## **Addenda 04** **Issued January 10, 2017**

**PROJECT TITLE: Harmony School of Innovation - Waco - Remodeling**

**HARMONY SCHOOL OF INNOVATION - WACO**

**EXTERIOR WINDOWS ALTERNATE #1 BID FORM**

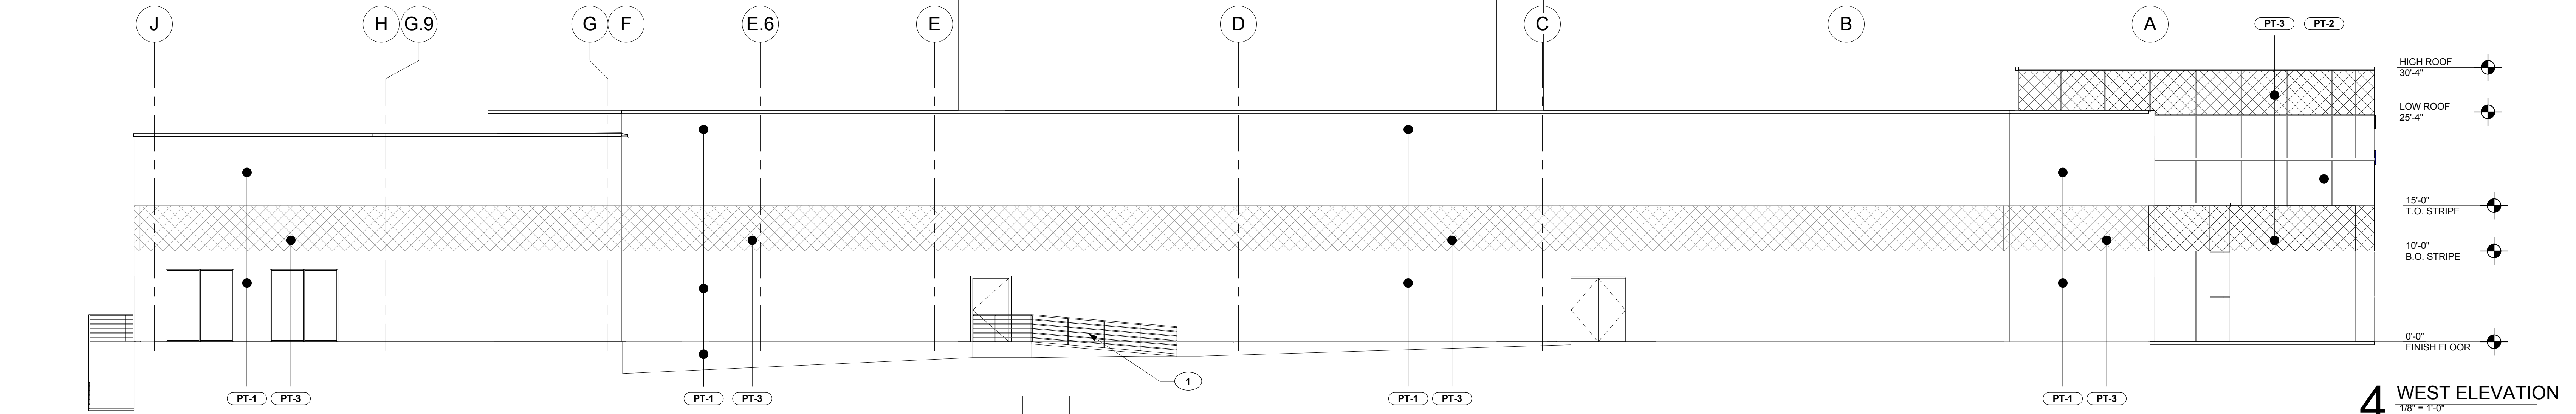
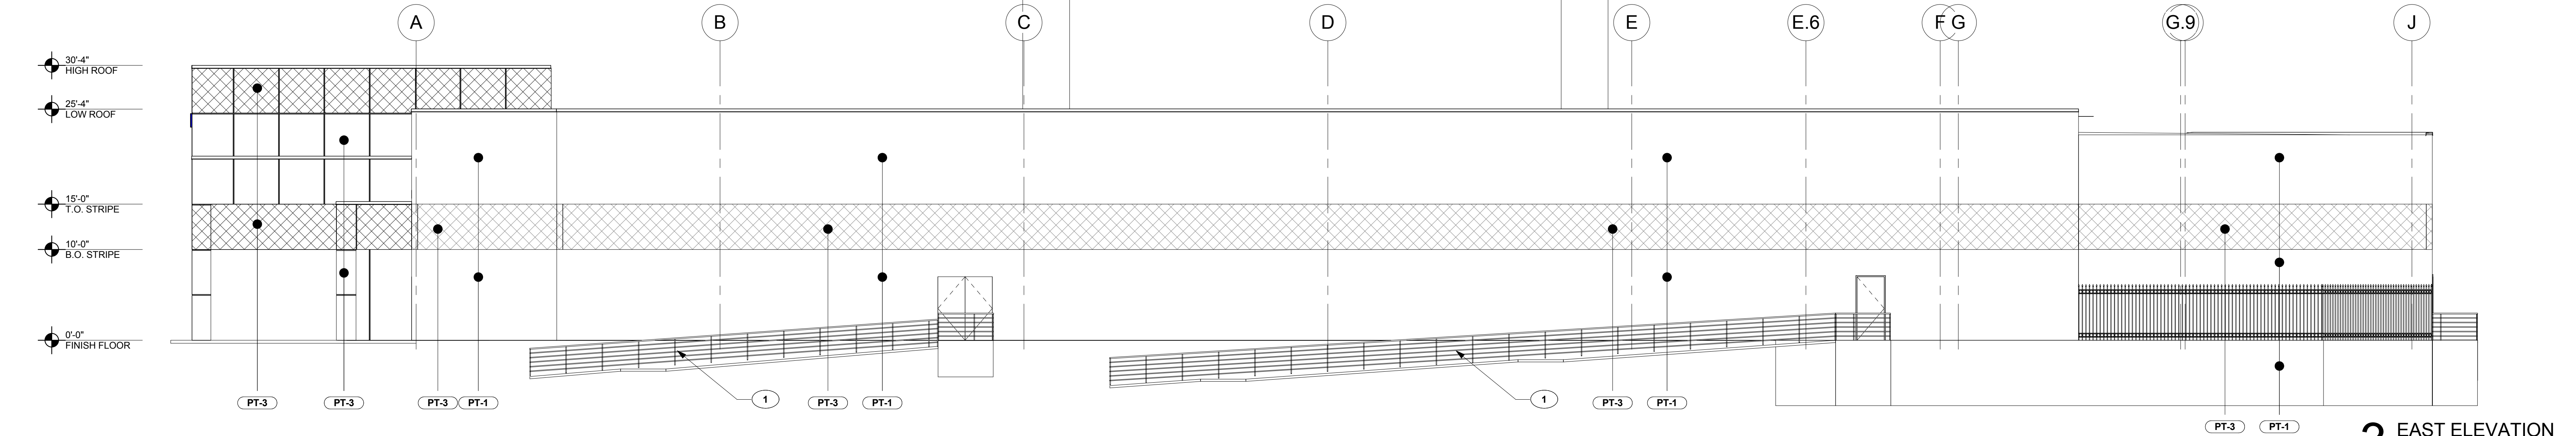
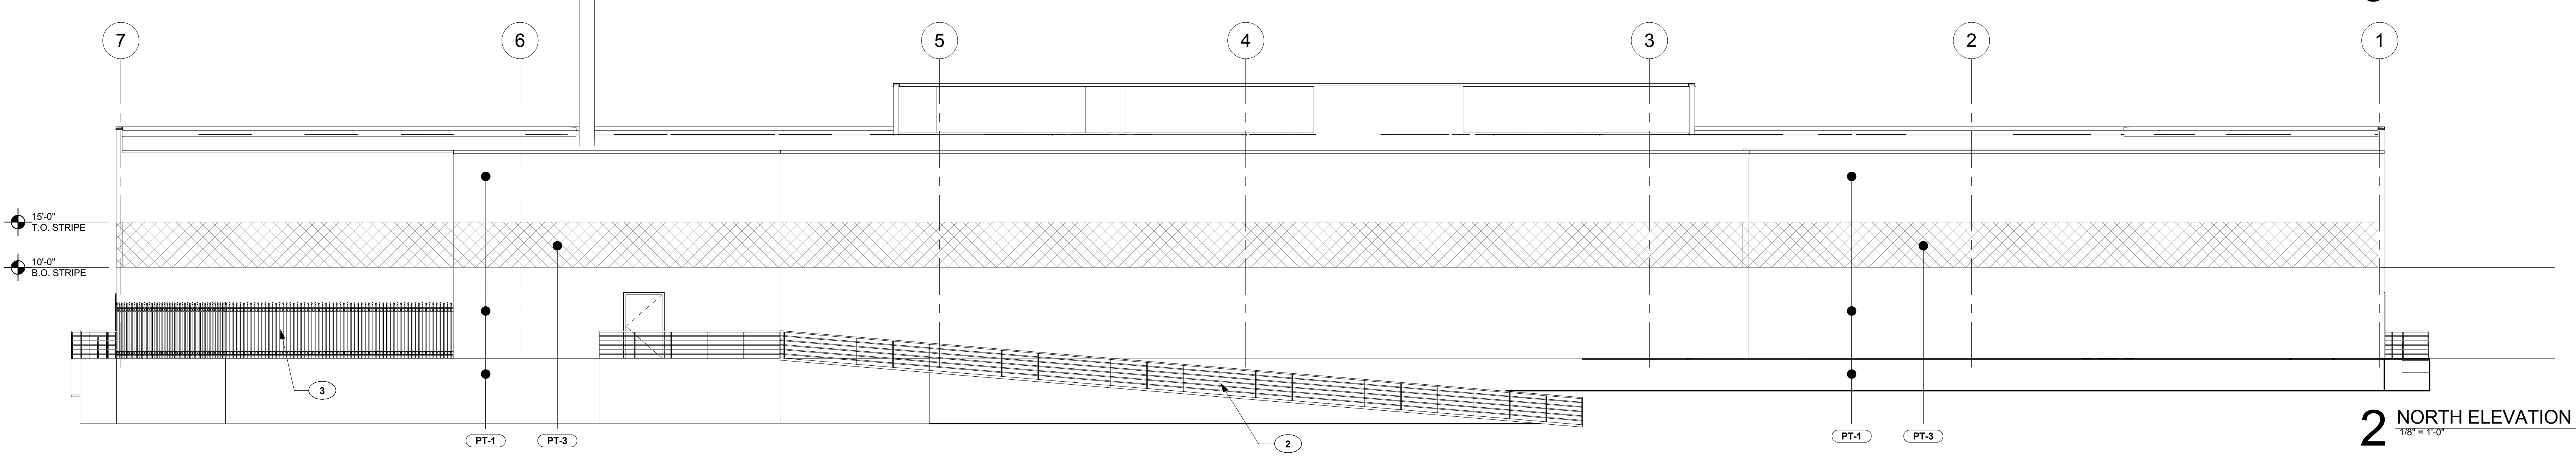
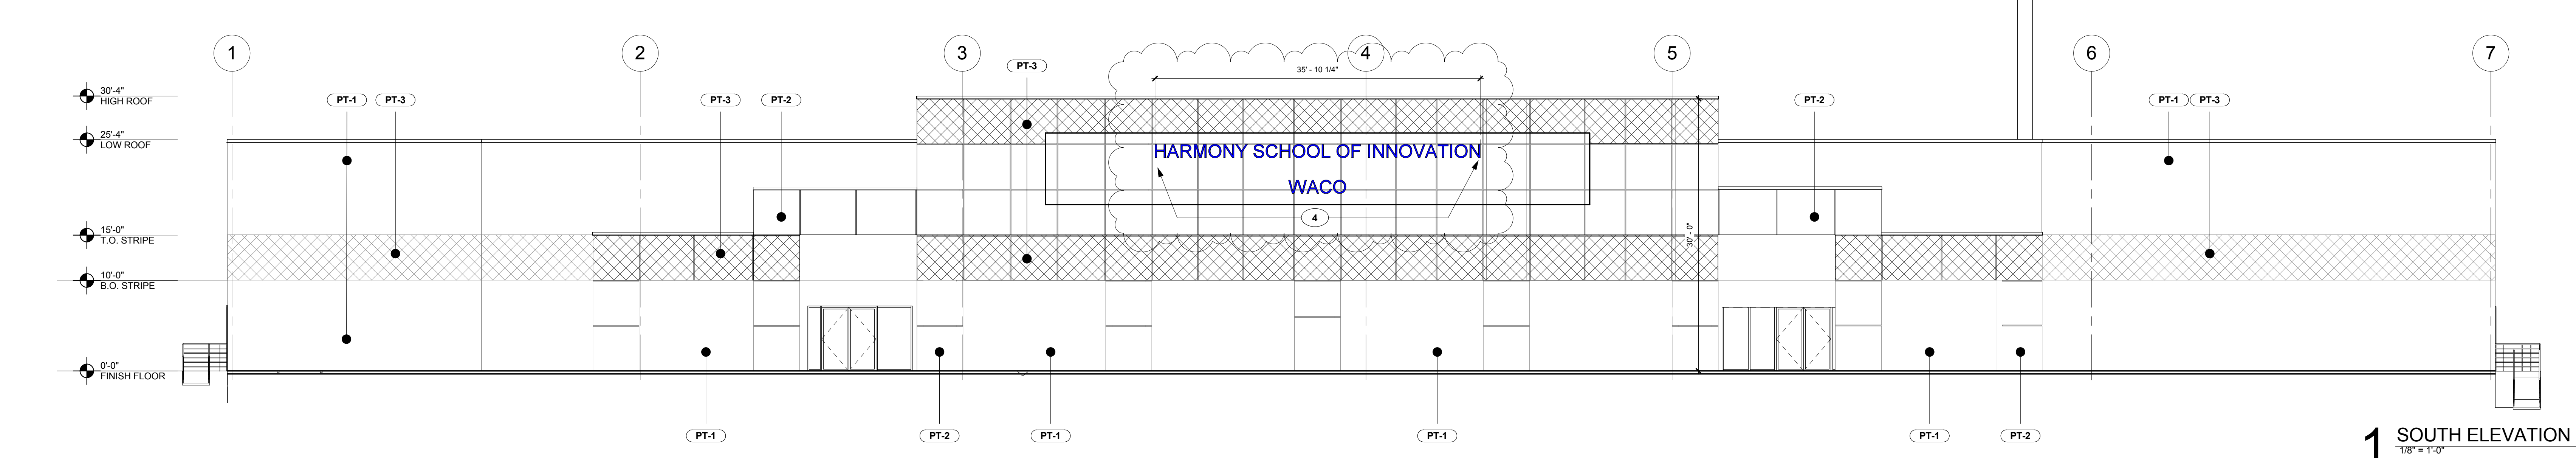
G.C. TO PRICE AS AN ALTERNATE ADDING 2'-4" W X 4' H 1" INSULATED FIXED WINDOWS. TWO WINDOWS WILL BE PLACED IN EACH CLASSROOM ALONG THE EXTERIOR PERIMETER WALLS. A TOTAL OF TEN WINDOWS. EXISTING WALLS ARE CMU AND WILL REQUIRE A LINTEL PER STRUCTURAL DETAIL 2/S2.0.

INCLUDE IN ESTIMATE CHANGING DOOR NUMBERS 128B, 128C, AND 155 TO STOREFRONT DOORS WITH A 12" SIDELITE ADDED TO THE DOOR WIDTH AS SEPARATE LINE ITEM.

INCLUDE IN ESTIMATE ADDING 2'-8" W X 7' H STOREFRONT WINDOWS IN CAFETERIA AS A SEPARATE LINE ITEM.

GLASS TO BE A MINIMUM SHGC OF .24. EQUAL TO PPG SOLARBAN 60, COLOR SOLARGRAY.

WINDOW MANUFACTURE TO BE KAWNEER TRIFAB OR AN APPROVED EQUAL.

INCLUDE AN ESTIMATED BUDGET FOR INCREASED HVAC TONNAGE AS A SEPARATE LINE ITEM IN THE ALTERNATE PRICE. AN ADDENDUM WILL BE ISSUED IF THE OWNER DECIDES TO USE THIS ALTERNATE.
